HISTORIC AND DESIGN REVIEW COMMISSION

HDRC CASE NO: 2019-283
ADDRESS: 138 S JOSEPHINE TOBIN
LEGAL DESCRIPTION: NCB 2027 BLK LOT A1
ZONING: R-6,H
CITY COUNCIL DIST.: 1
DISTRICT: Woodlawn Lake and Park Historic District
APPLICANT: Melissa Douglas/Douglas Architects, Inc.
OWNER: Cathleen Crabb/CITY OF SAN ANTONIO
TYPE OF WORK: Final approval the new construction of a community center
APPLICATION RECEIVED: October 18, 2019
60-DAY REVIEW: December 17, 2019
CASE MANAGER: Stephanie Phillips
REQUEST:

COSA Woodlawn Lake Recreation Center

APPLICATION FOR FINAL APPROVAL

Interpretive Element Paying Tribute to Berta Almaguer

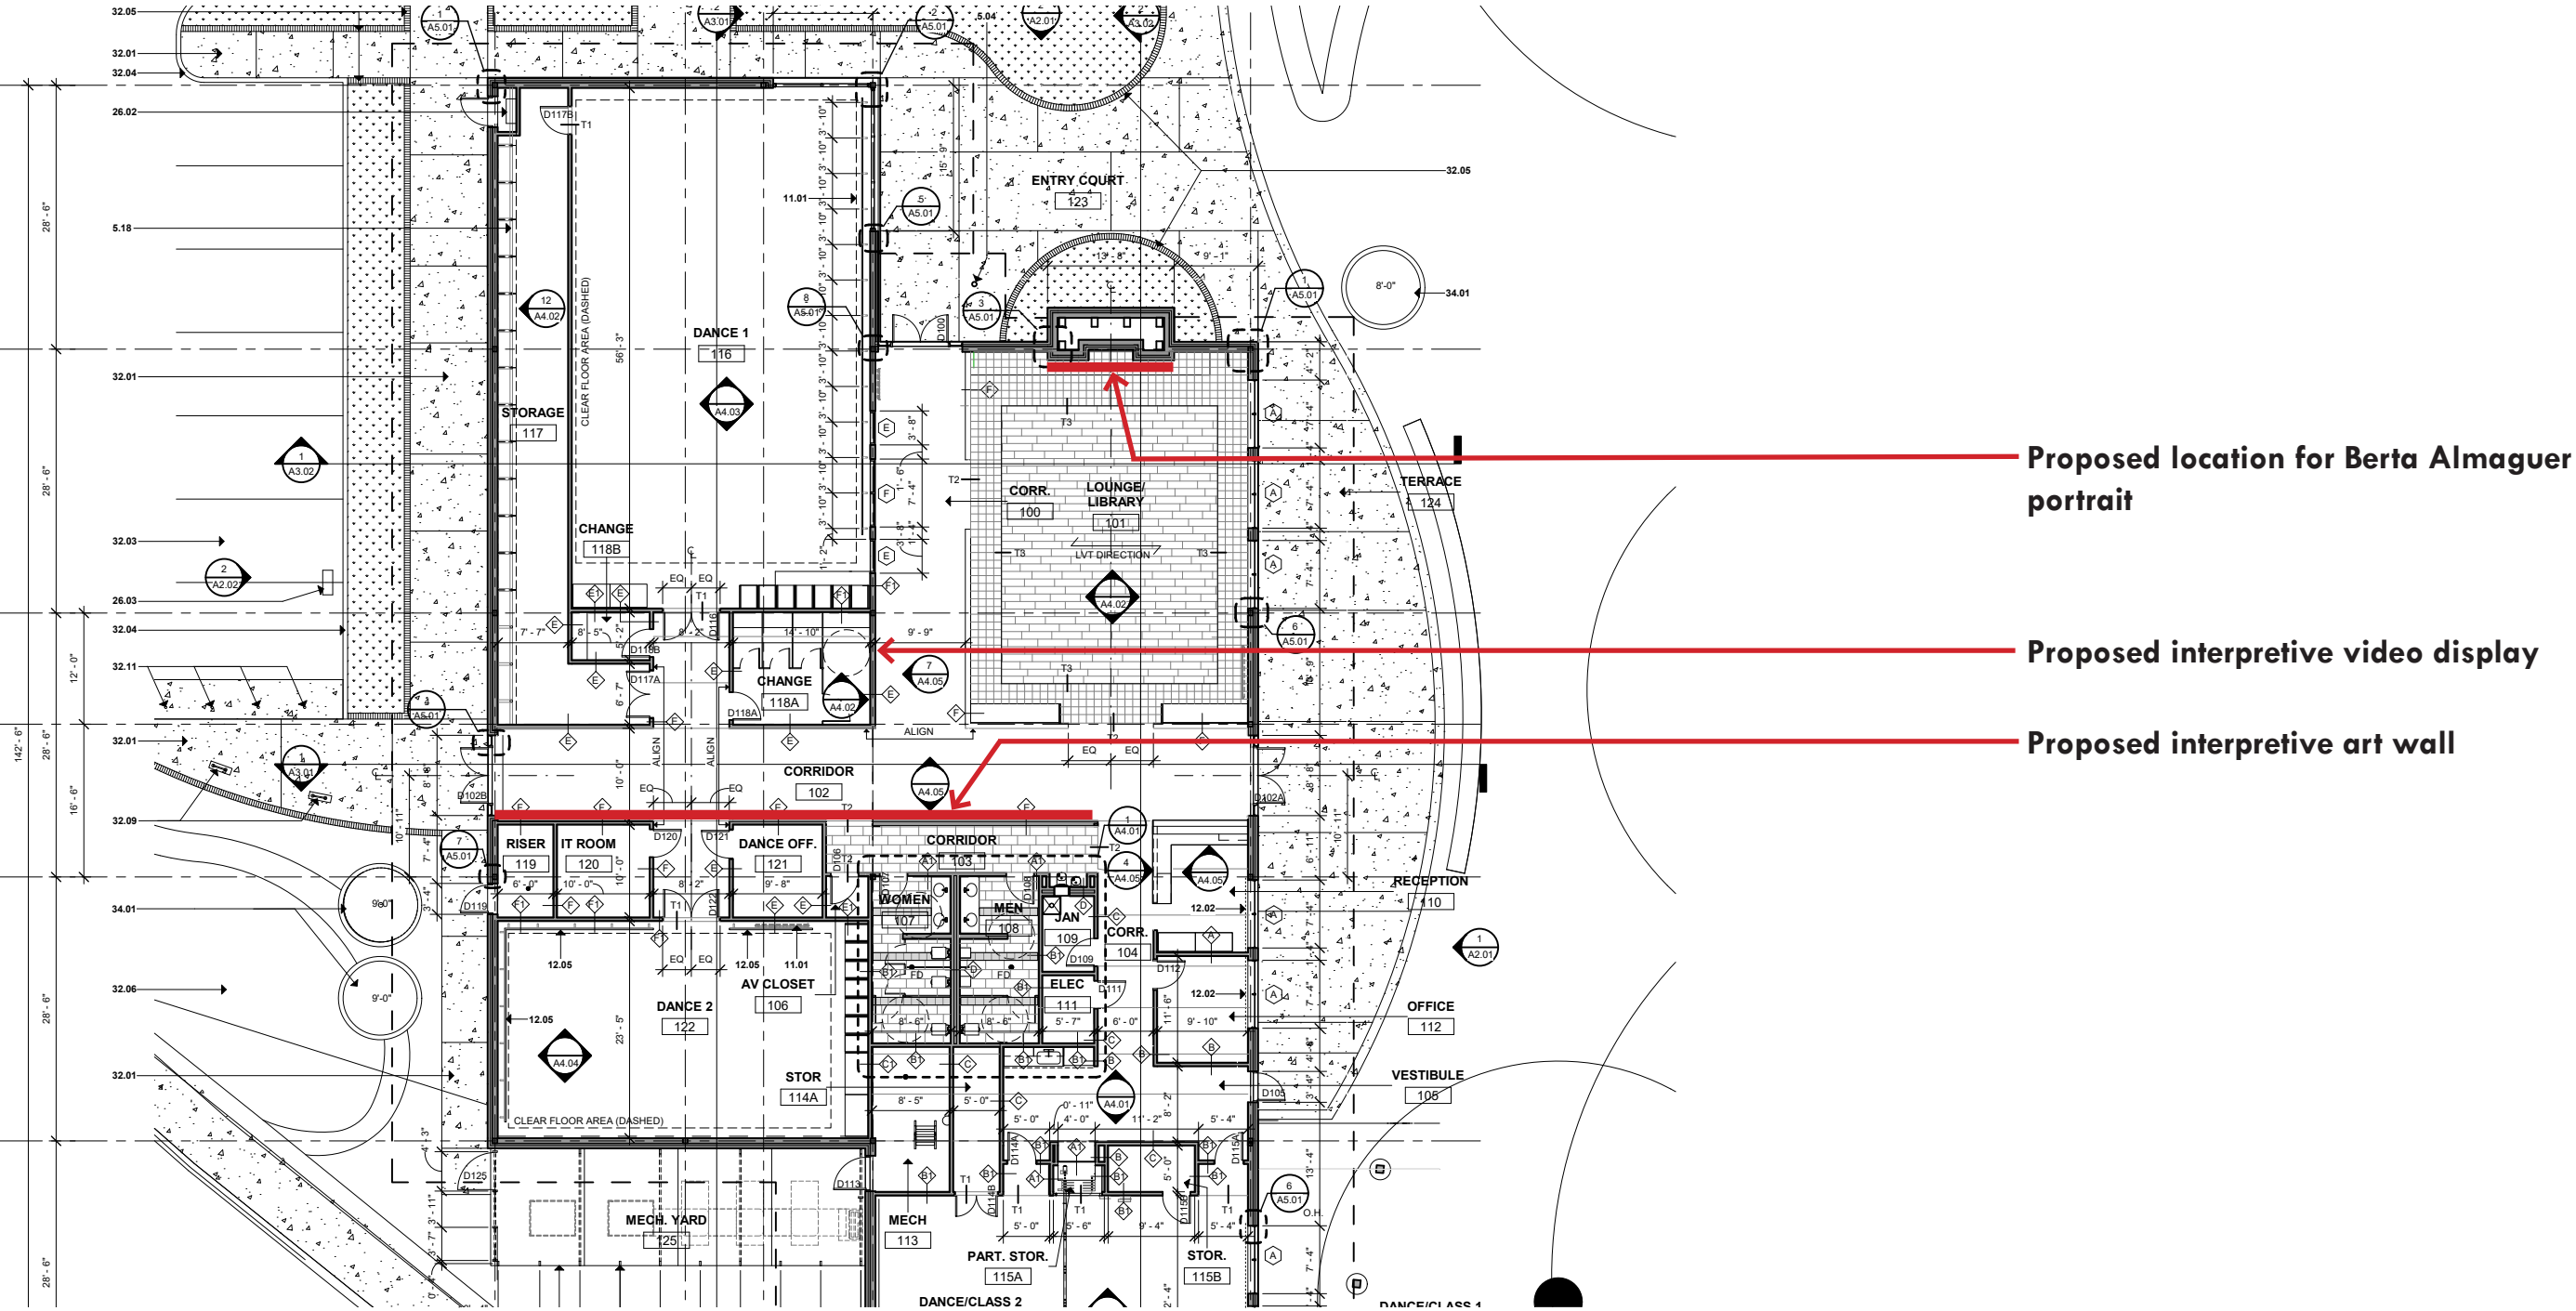
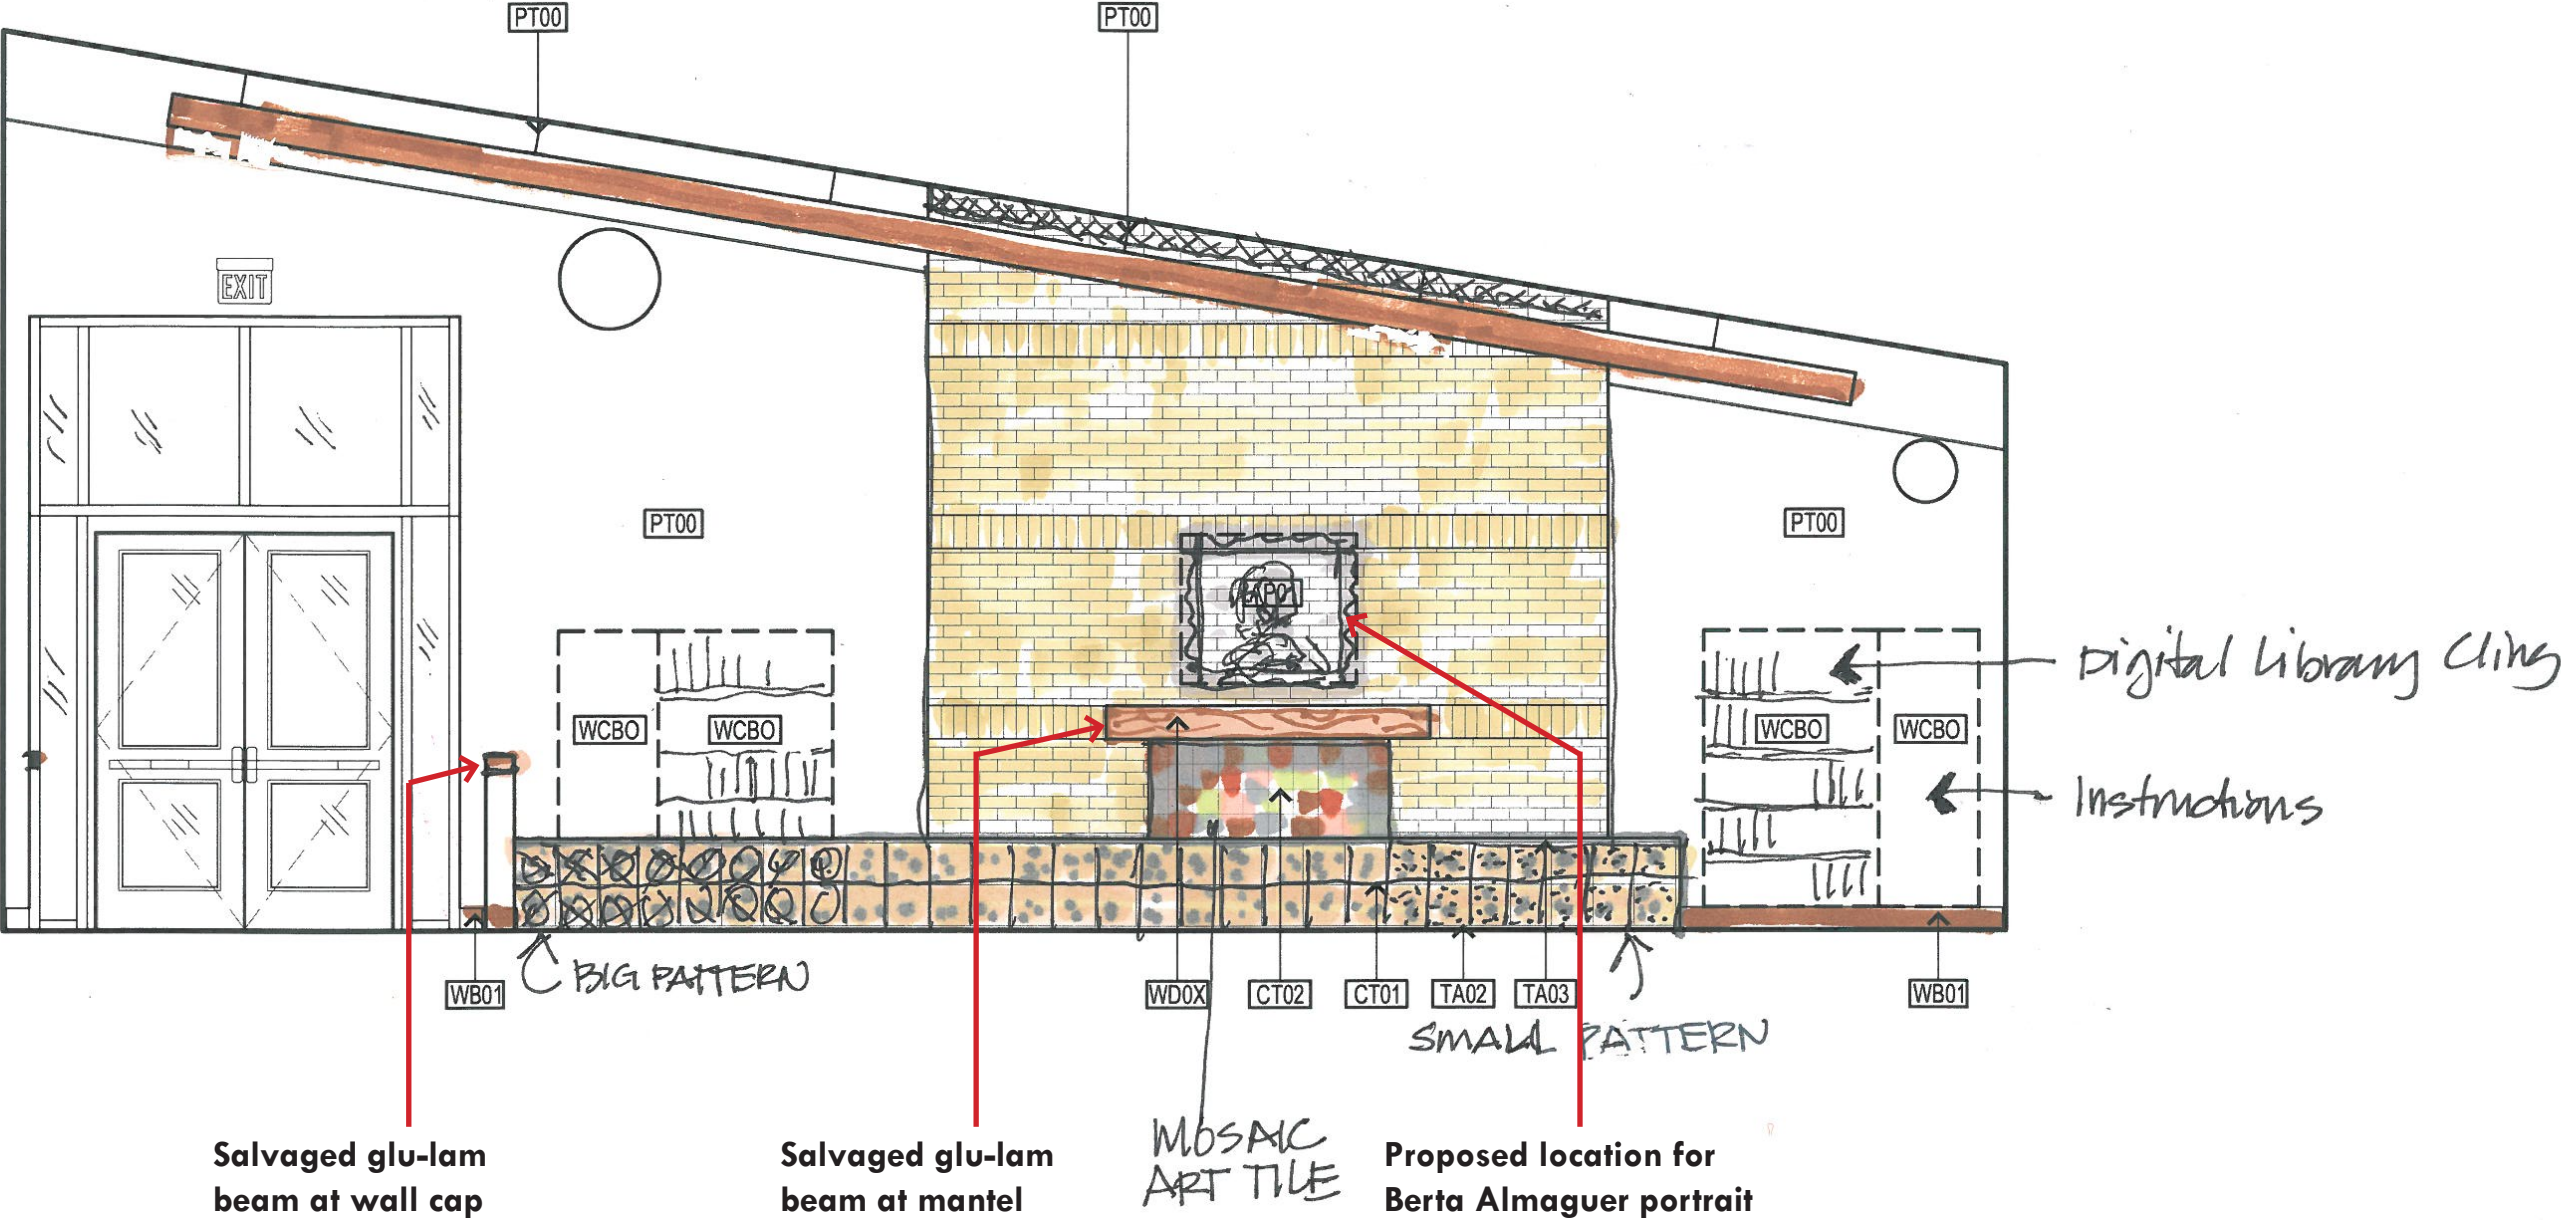
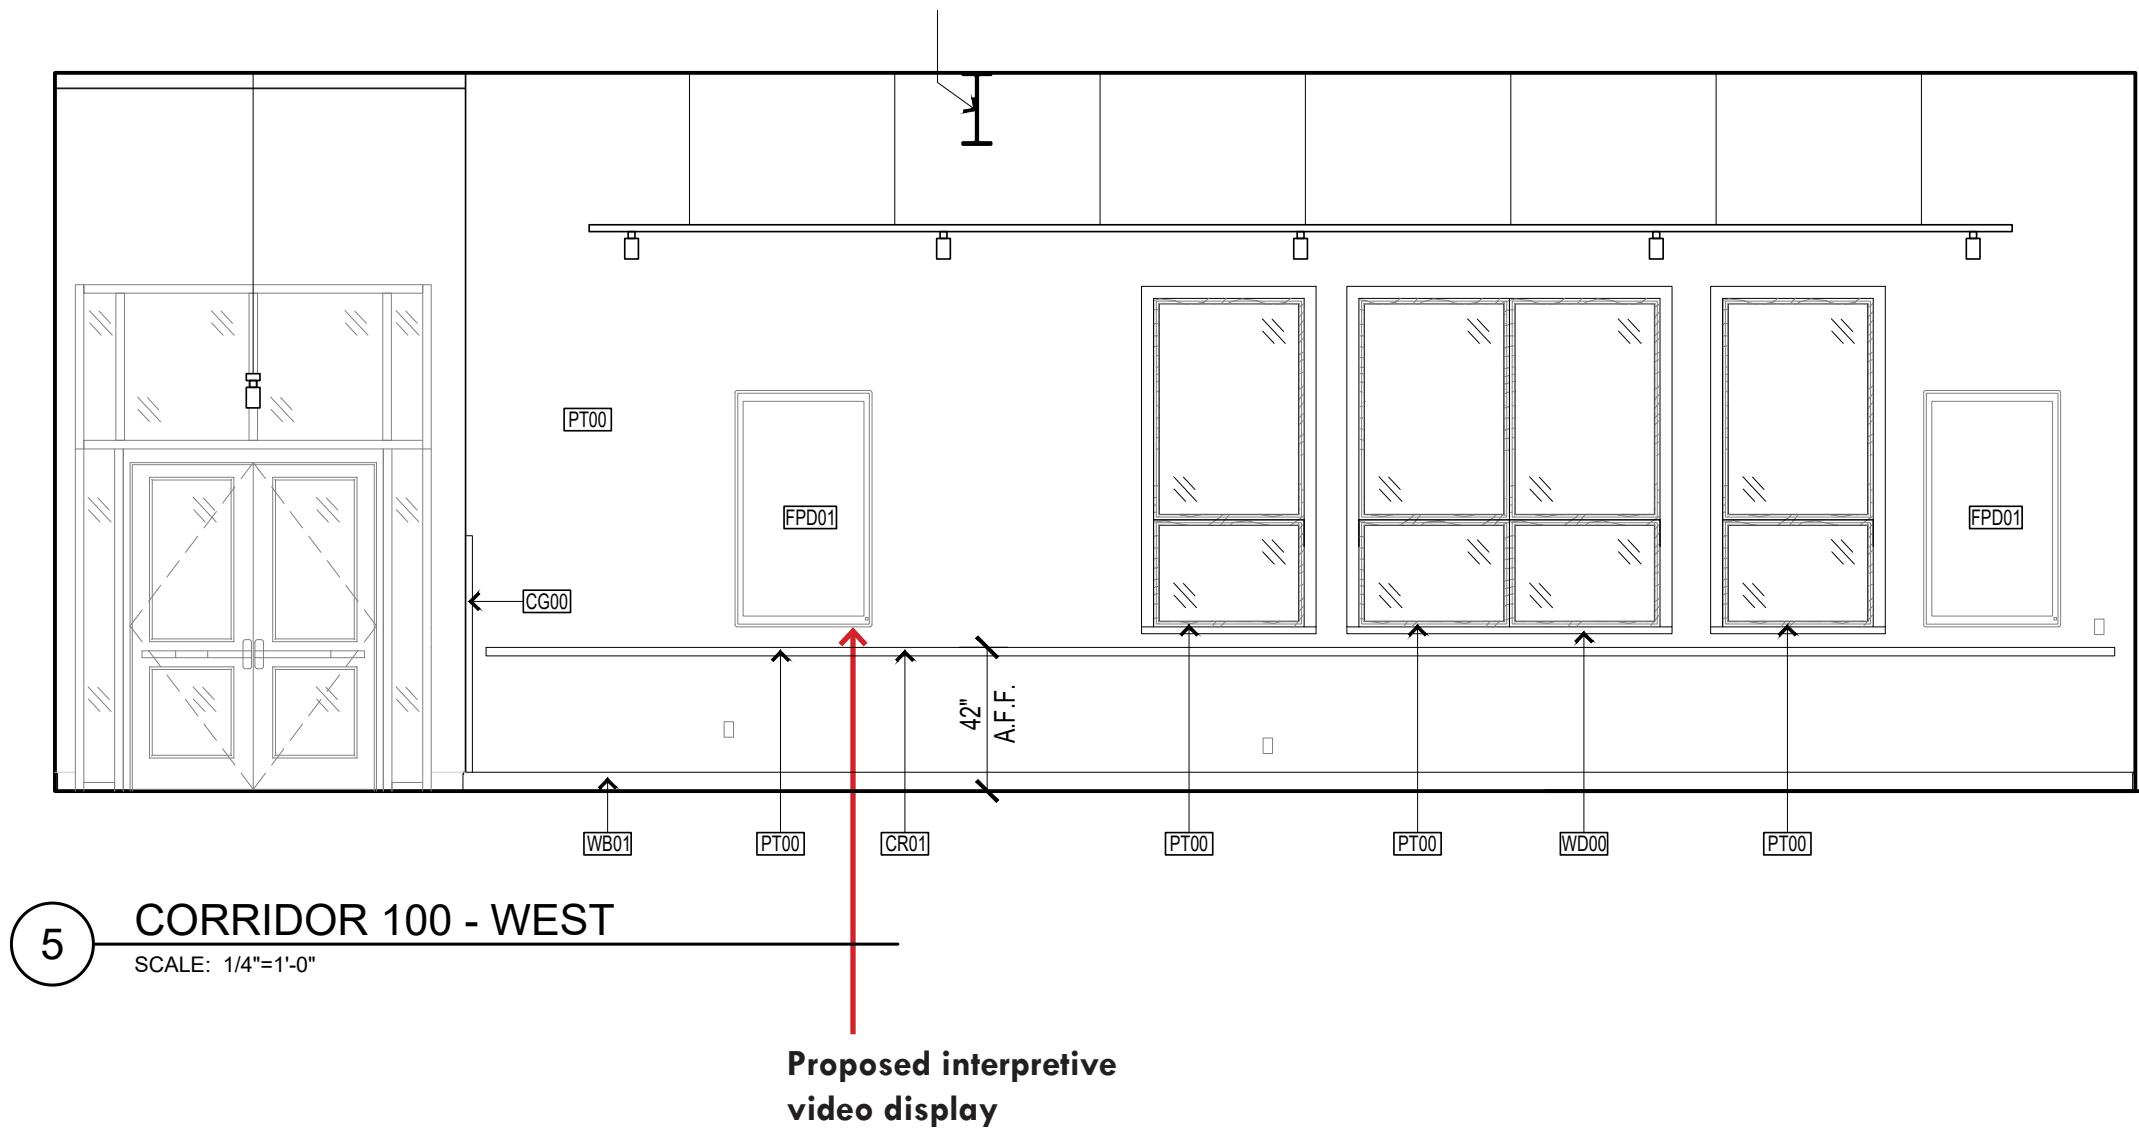
3. That the design includes an interpretative element. A gallery of images and video paying tribute to Berta Almaguer should be incorporated in the lobby (or other highly visible and sizeable area approved by HDRC). The gallery should include interpretative text describing Ms. Almaguer's contributions to the cultural heritage of San Antonio using research and materials existing in archives of the City of San Antonio Parks and Recreation Department; **this stipulation will carry over to final approval.**

- j. INTERPRETIVE ELEMENT – The existing structure is significant to the cultural heritage and image of San Antonio. Per the stipulations from conceptual approval, the design must include an interpretative element. Per the applicant's submission, a gallery of images and video paying tribute to Berta Almaguer will be incorporated in the lobby and will include interpretative text describing Ms. Almaguer's contributions to the cultural heritage of San Antonio using research and materials existing in archives of the City of San Antonio Parks and Recreation Department. Staff finds the proposal consistent.
